Re: S/D 92-66 THE DUGAN CENTRE SECOND ADDITION (Final Plat)

STAFF REPORT
(Final Plat Approved 12/10/92)

CASE NUMBER: S/D 92-66 - THE DUGAN CENTRE SECOND ADDITION

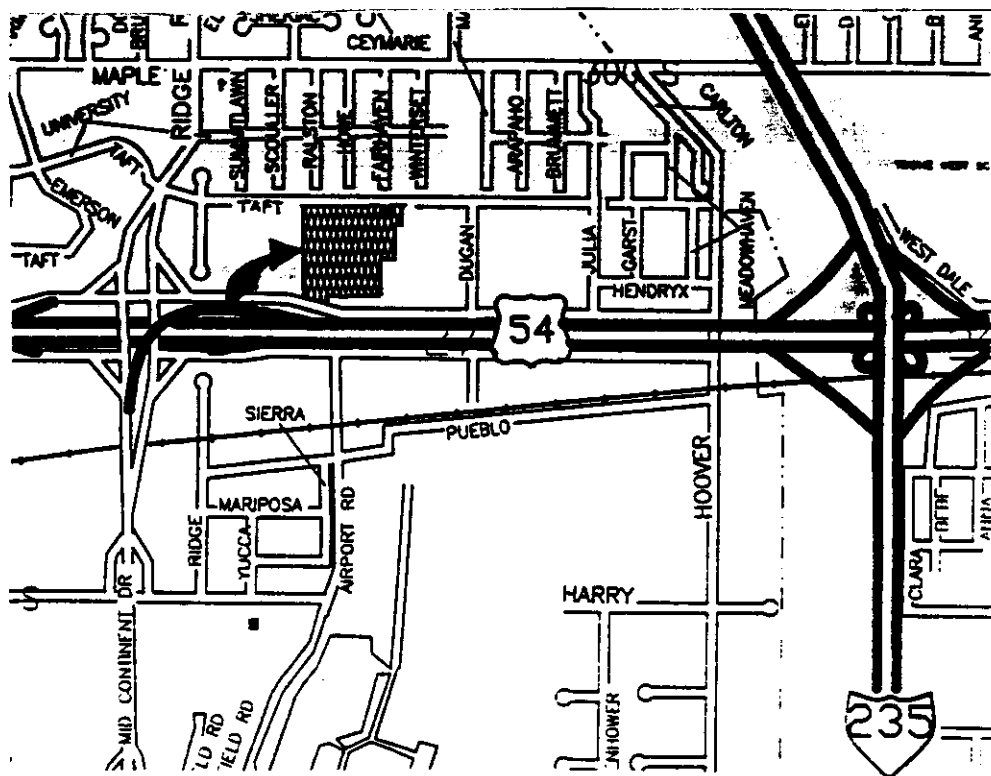
- K. The final plat shall state in the plat's text the purposes of the proposed reserves as well as who is to own and maintain the reserves.
- L. Provisions shall be made for ownership and maintenance of the proposed reserves. The applicant shall either form a lot owners' association prior to recording the plat or shall submit a covenant stating when the association will be formed, when the reserves will be deeded to the association and who is to own and maintain the reserves prior to the association taking over those responsibilities.

- M. For those reserves being platted for drainage purposes, the required covenant which provides for ownership and maintenance of the reserves shall grant, to the City, the authority to maintain the drainage reserves in the event the owner(s) fail to do so. The covenant shall provide for the cost of such maintenance to be charged back to the owner(s) by a method similar to special assessments.

- N. The applicant is advised that a portion of Lot 1 is within an indicated FEMA flood area, and that prior to a building being allowed in this area, revision of the FEMA flood map will be necessary.

- O. The indicated minimum building pad elevation shall also be referenced in the plat's text. It shall also be indicated if this elevation involves the lowest opening or floor level. Also, the required elevation shall be three (3) feet higher than presently dedicated.

- A. The applicant shall submit a guarantee to extend sanitary sewer to all of the lots now being platted and shall either resubmit petitions or submit square footage information so that existing guarantees can be respread (water, drainage, etc.).

- Also, the final plat tracing shall indicate any additional easements needed for the extension of sanitary sewer, or to cover existing sewer lines such as to Lot 2.

- C. On the final plat tracing, Taft, adjacent to the north line of this plat shall be indicated with the center line and half street right-of-way shown.

- D. Prior to this plat being scheduled for City Council review, the applicant shall obtain an adjustment to CUP, DP-151, Amendment #1, so that the boundaries of the plat correspond to the CUP's parcel boundaries. The applicant is advised that as now indicated in the CUP only four (4) buildings, one per lot, would be expected.

- E. On the final plat tracing, the note in regard to building setbacks should be amended to indicate that the CUP is DP-151, "Amendment #1".
- F. For Lots 3 and 4, since access is being allowed to Taft, the word "complete" should be eliminated from the face of the plat, north of these lots.

- G. For Lot 2, either an agreement needs to be recorded which allows access to it from Lot 1 or a private access easement needs to be established and shown on this plat with appropriate recording information. If an agreement is used, a recorded copy shall be submitted for the plat file.

- H. In terms of the access easement along the west line of Lot 1, since this is a private easement, the applicant shall record this easement and show the recording information on the final plat tracing. A copy shall be provided for the plat file.

- I. The applicant is advised that the access of Lot 1, to Taft will be counted as one of the openings originally allocated to Parcel 4 of the CUP.
- J. The final plat shall indicate the platting of a Reserve, for drainage, rather than the drainage dedication as is presently being indicated.
